**PZ&B Staff Combination Memorandum: Landmarks Preservation Commission and Town Council**

**SUBJECT:** HSB-24-0003 (ZON-24-0022) 346 SEASPRAY AVENUE (COMBO)

**MEETING:** JULY 17, 2024, LPC  
AUGUST 12, 2024, TC

03 PROPOSED NORTH ELEVATION  
 SCALE 3/32" = 1'-0"

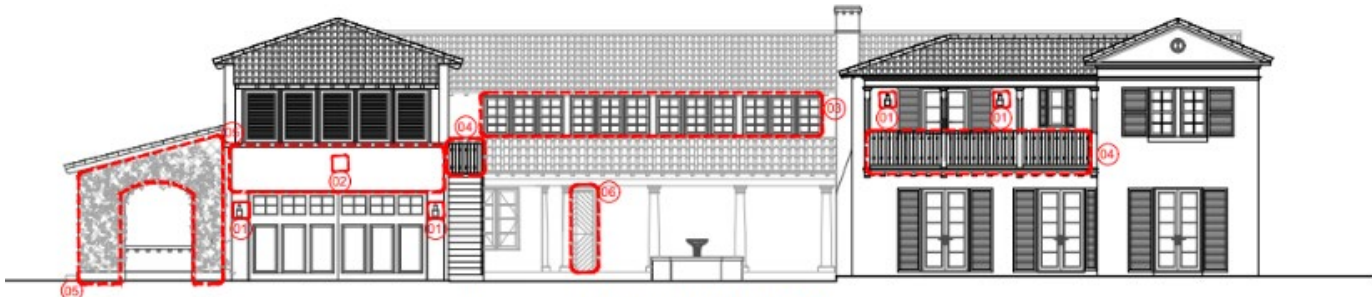
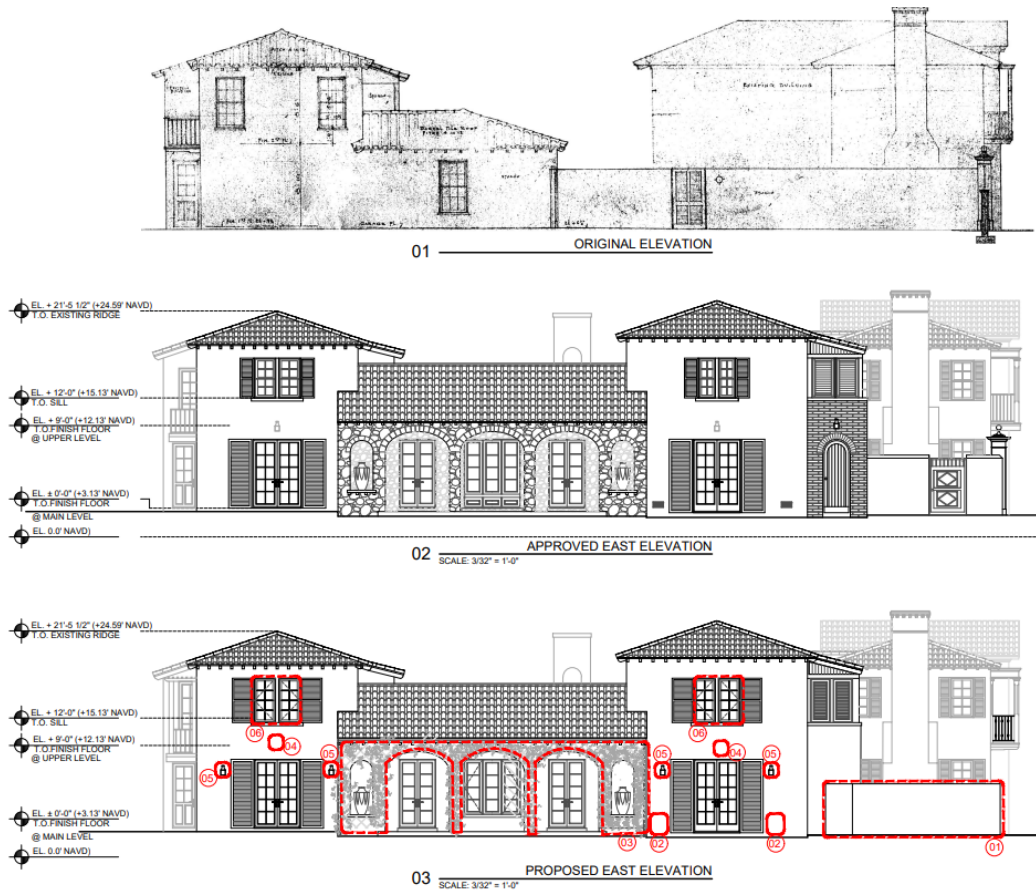
On the north elevation (fronting Seaspray Ave), removal and relocation of light fixtures, shutter removal, redesign of railings, changes to exterior finishes to smooth stucco in locations where masonry was previously approved, and a new exterior door is proposed. From a historic preservation perspective, maintaining a smooth stucco exterior finish is appropriate based on the original architectural plans. In addition, the removal of the second-story loggia shutters is also acceptable since they are not original features. However, staff has concerns regarding the design of the new door and railings. The design of the doors, similar to the new gates, is not compatible with the architectural style of the building. Both the new exterior door and railings present a valuable opportunity to reconstitute original design features. Staff recommends further study of these features.

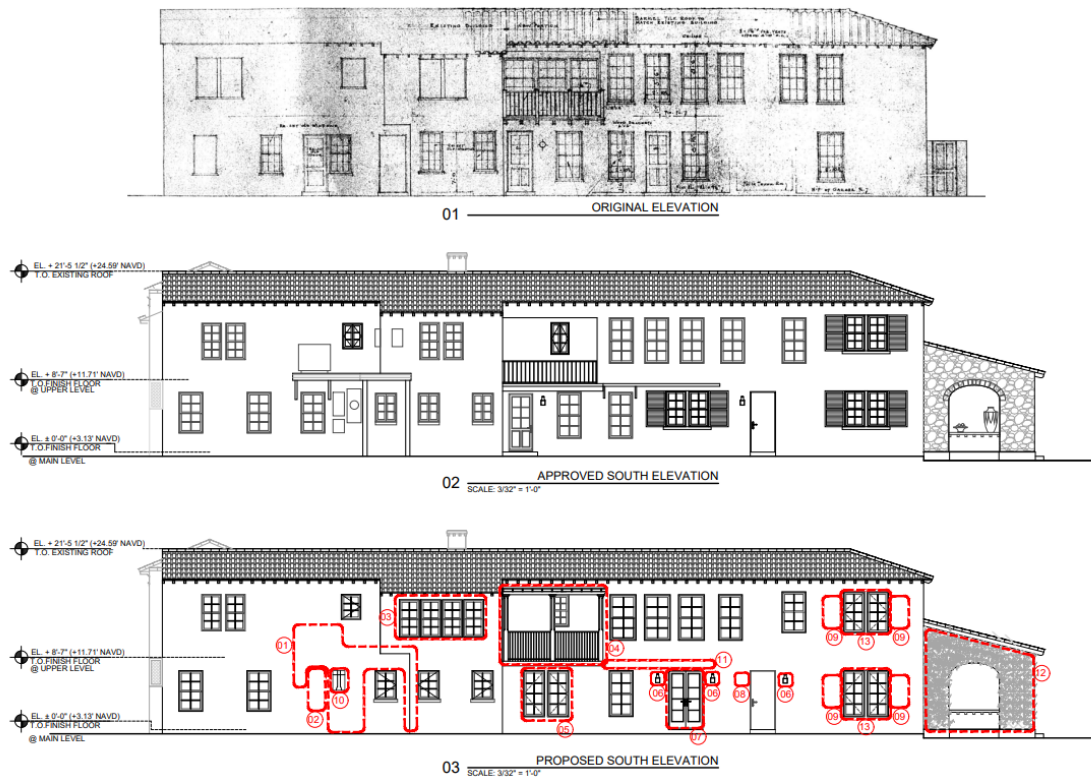
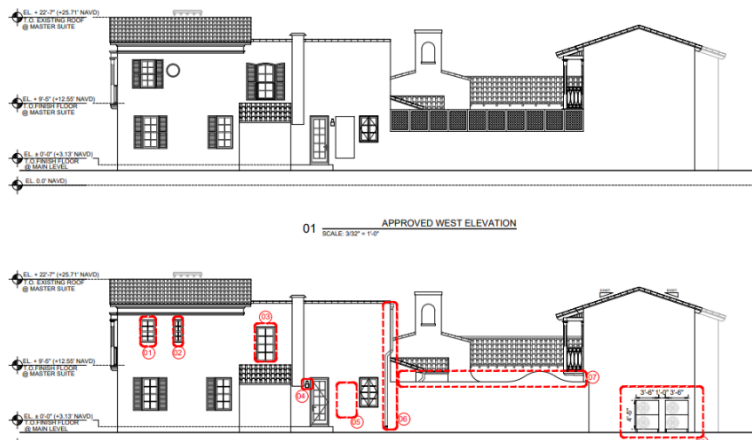
On the south elevation, mechanical equipment was removed, windows were removed and added, a new pair of French doors was proposed, light fixtures were added and relocated, shutters were removed, an overhang was removed, a new second-story trellis was added to an existing balcony, and changes to exterior finishes to smooth stucco in locations where masonry was previously approved are proposed. As previously discussed, the removal of shutters and the smooth stucco exterior finish is consistent with the original plans. Staff has concerns related to removing or relocating original openings and the use of casement windows instead of hung windows. However, changes to rear facades can be given greater flexibility due to their low level of visibility.

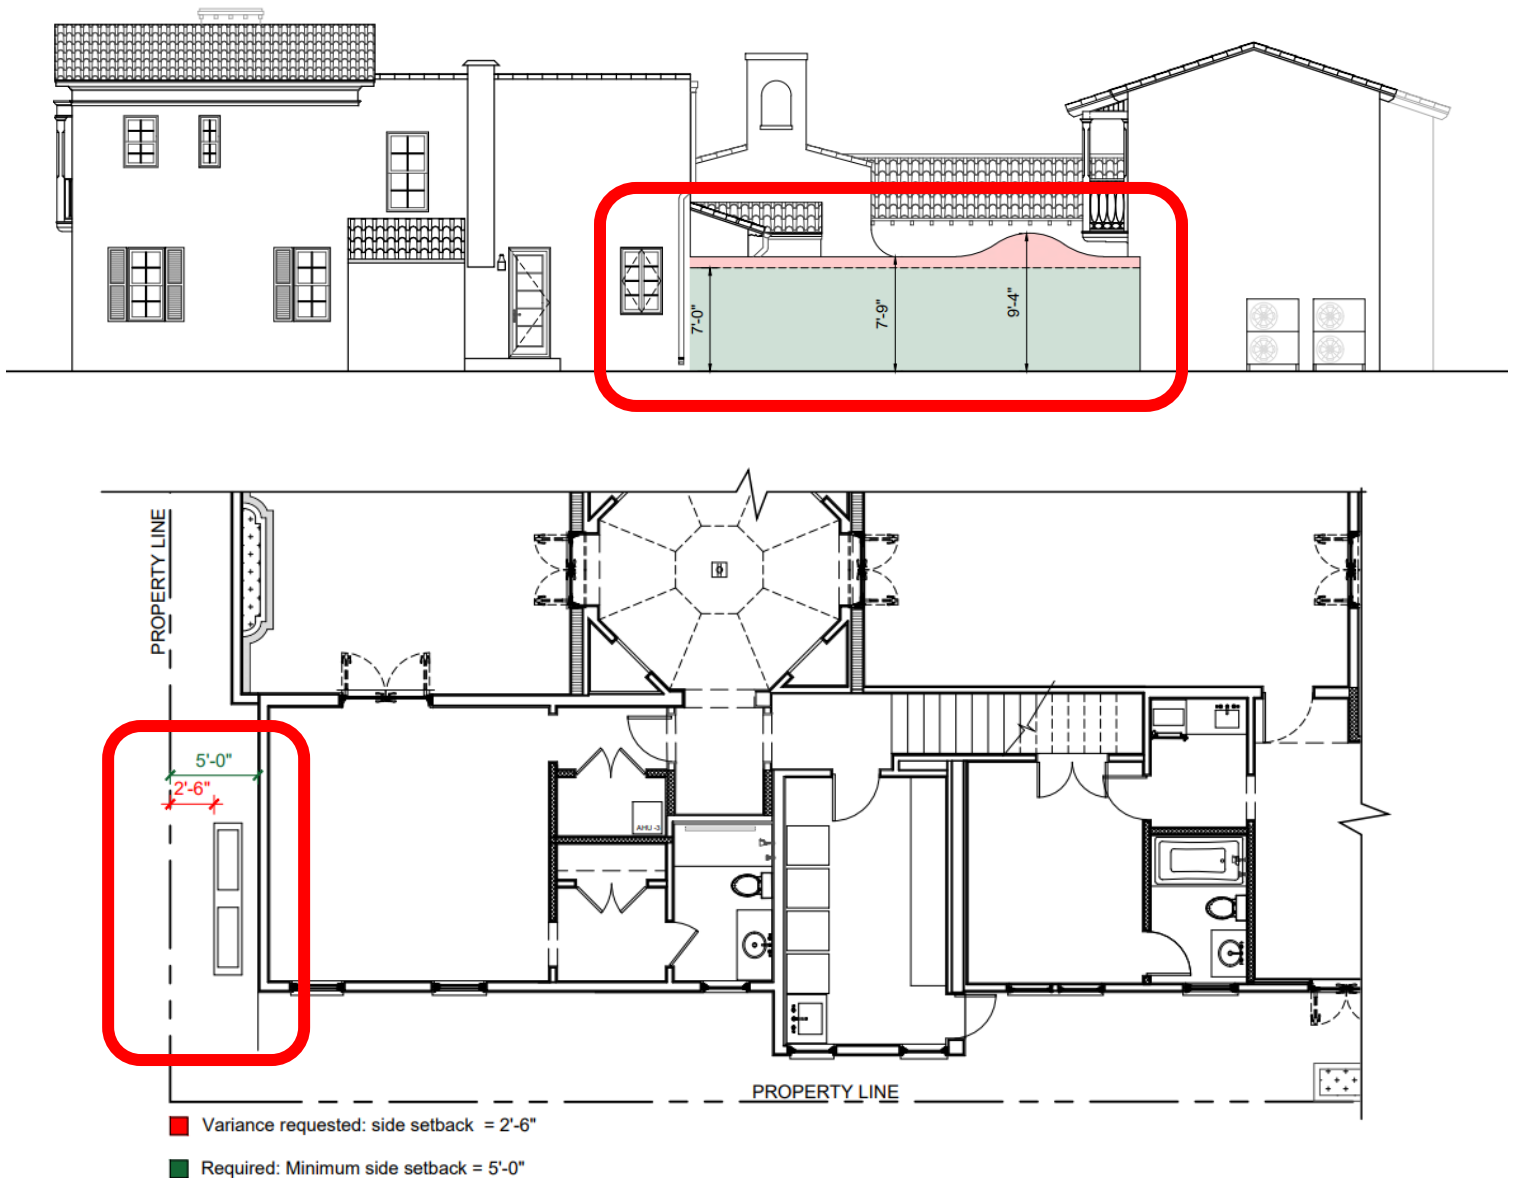
Code Section	Required	Proposed	Variance
<b>Variance #1:</b> Sec. 134-1728(a)	5'-0" Mechanical Equipment Side Yard Setback	2'-6" Mechanical Equipment Side Yard Setback	2'-6"
<b>Variance #2:</b> Sec. 134-1669	7'-0" Side Yard Site Wall Height	9'-4" Side Yard Site Wall Height	2'-4"

As explained by the applicant in the letter of intent, additional wall height is requested to replace the privacy that was offered by the lattice. Furthermore, the applicant contends that there is no other feasible location for the mechanical equipment other than where it is proposed within the side yard setback. Staff has concerns that the work was already completed without approvals or variances. In addition, the subject property is much larger than the typical R-B zoned lot. There are likely several solutions that would avoid the need for variances by considering other locations for the mechanical equipment and using landscaping to achieve greater privacy where additional wall height is desired.
